**CCW IMPOUNDMENTS
INSPECTION REPORT**

**BRUCE MANSFIELD POWER
PLANT
BEAVER COUNTY,
PENNSYLVANIA**

**PROJECT NO. 09-4157
OCTOBER 2009**

TYPICAL SECTION
TYP. ALL DIKES
(N.T.S.)

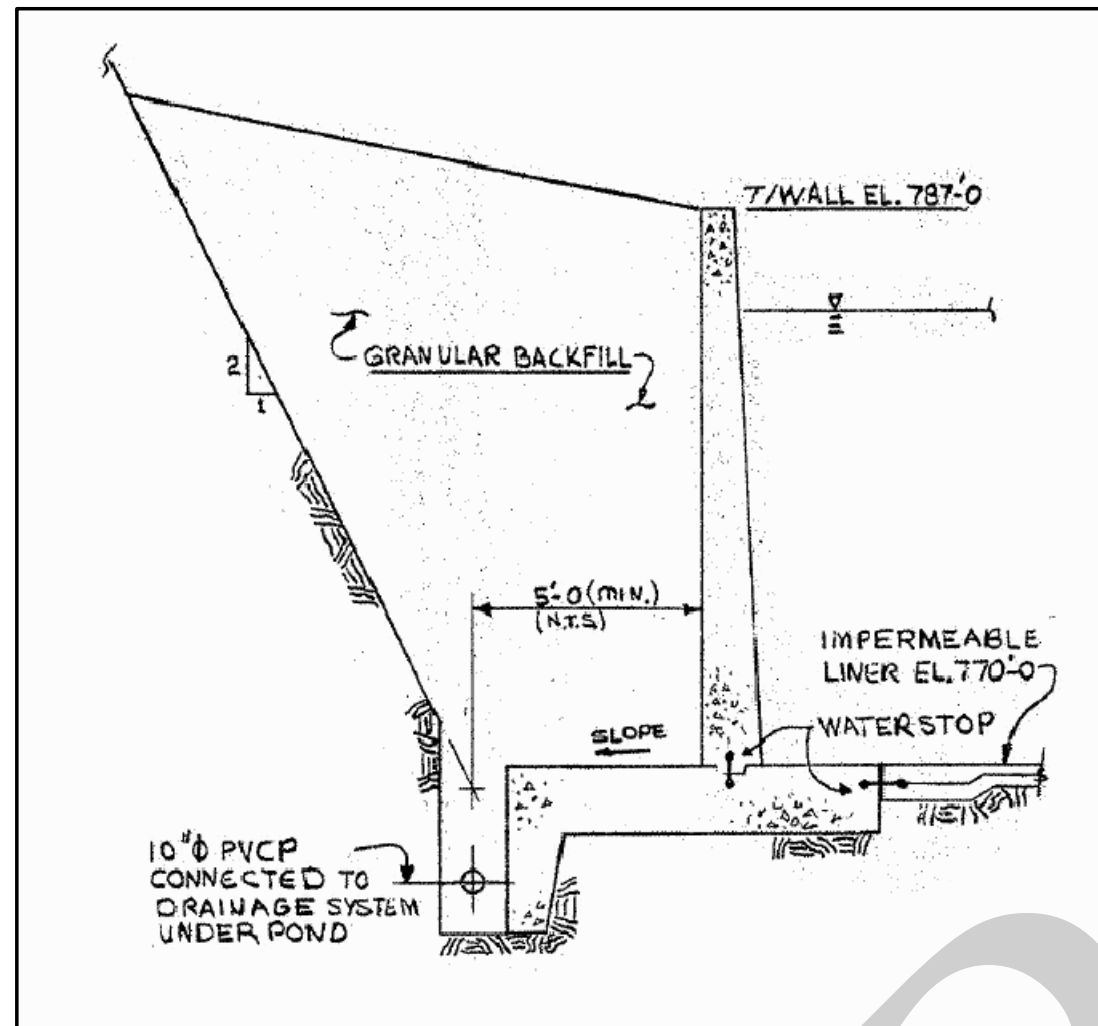
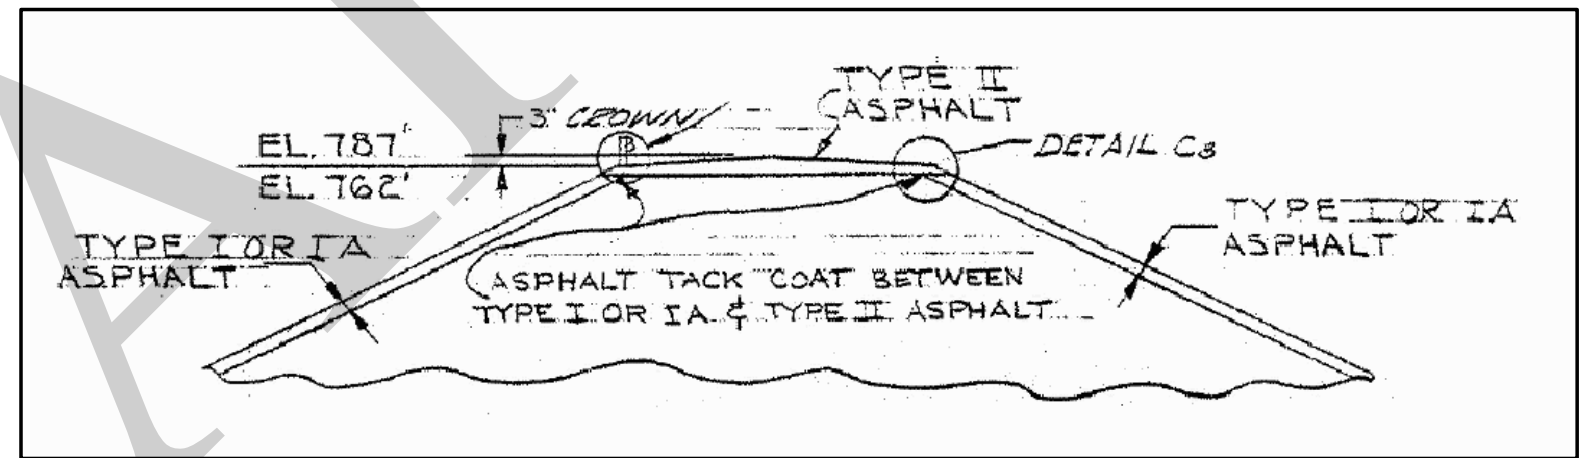
The stability of the embankments for each management unit was analyzed as described in **Section 2.4.2** of this report. The resulting factors of safety exceed the requirements for all load cases. However, it is not clear how the soil parameters were selected since there is no subsurface information and/or laboratory testing data for the soils at the location of the management units. We expect that the engineering documentation for the power plant includes geotechnical information for the entire Site, and that this information was likely used to select the soil strength parameters. Our review of available published geologic information for the Site suggests that the site soils likely consisted of sands and gravels. This is consistent with the use of an asphalt liner placed on the upstream slope to control seepage. On the other hand, the use of a friction angle of 30° and a cohesion value of 500 pounds per square foot for the soil shear strength suggests that a cohesive soil consisting of low plasticity clay may have been used to construct the embankments. The shear strength of a soil consisting of sand and gravel soil would be characterized by a friction angles varying from 30 to 38° and no cohesion. Considering the adequate structural performance of the embankments over the last 34 years, we conclude that the embankments have an adequate factor of safety against slope stability. This is consistent with the evaluation performed by PADEP. However, given the uncertainty with the subsurface conditions and associated shear strength parameters, the factors of safety reported in **Section 2.4.2** may be overestimated.

We recommend that the surface asphalt along the crest and downstream slopes of all embankments continue to be maintained as part of the plant facility's regular maintenance activities. Clearing of vegetation, sealing of cracks, and repair of larger defects should be performed on a regular basis. The hydrologic study for the site states that SDF will overtop the impoundments by approximately 0.3 foot. Passage of the SDF without erosion of the embankments is dependent on the asphalt layer, and it should not be allowed to degrade to a point where an overtopping could cause a failure.

PENNSYLVANIA POWER COMPANY
BRUCE MANSFIELD PLANT HDS and LDS PONDS
DIKE STABILITY - DRY CASE

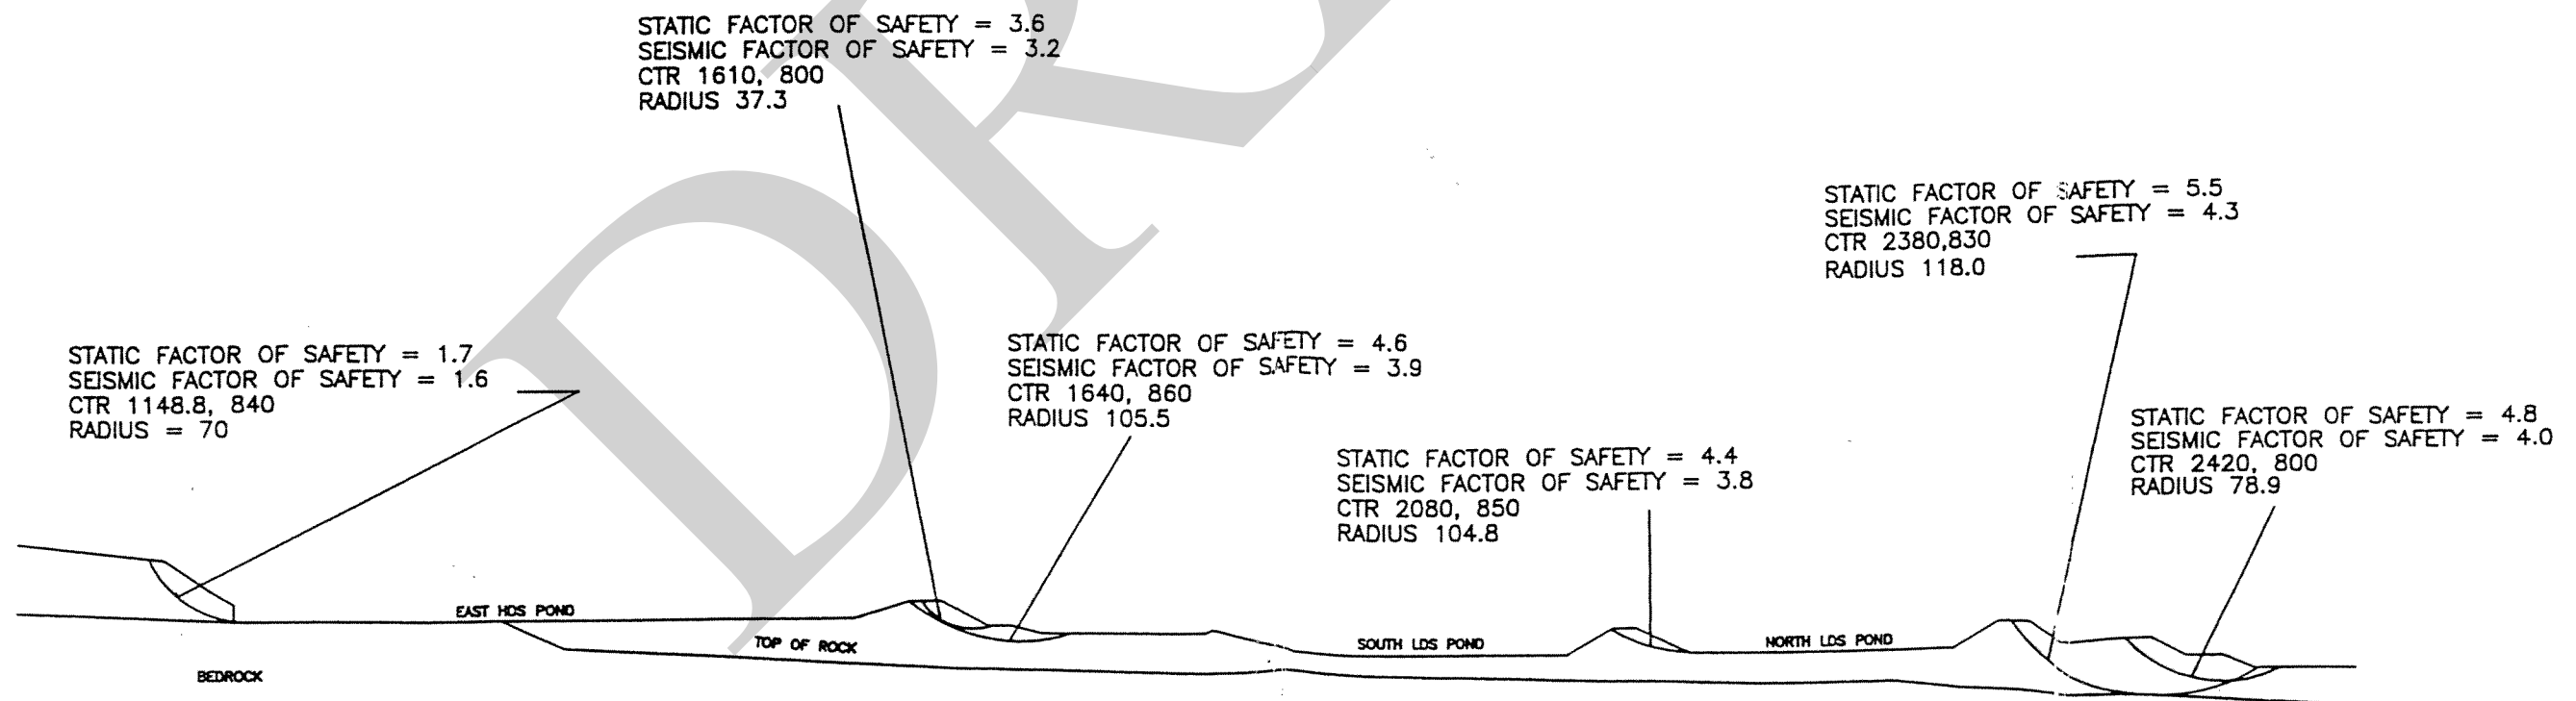
The required factors of safety are exceeded for all load cases and all structures. A review of the analysis showed that for the Saturated Case a phreatic line exists within the embankments and can be considered conservative assuming the impermeable liner fails to functions as designed.
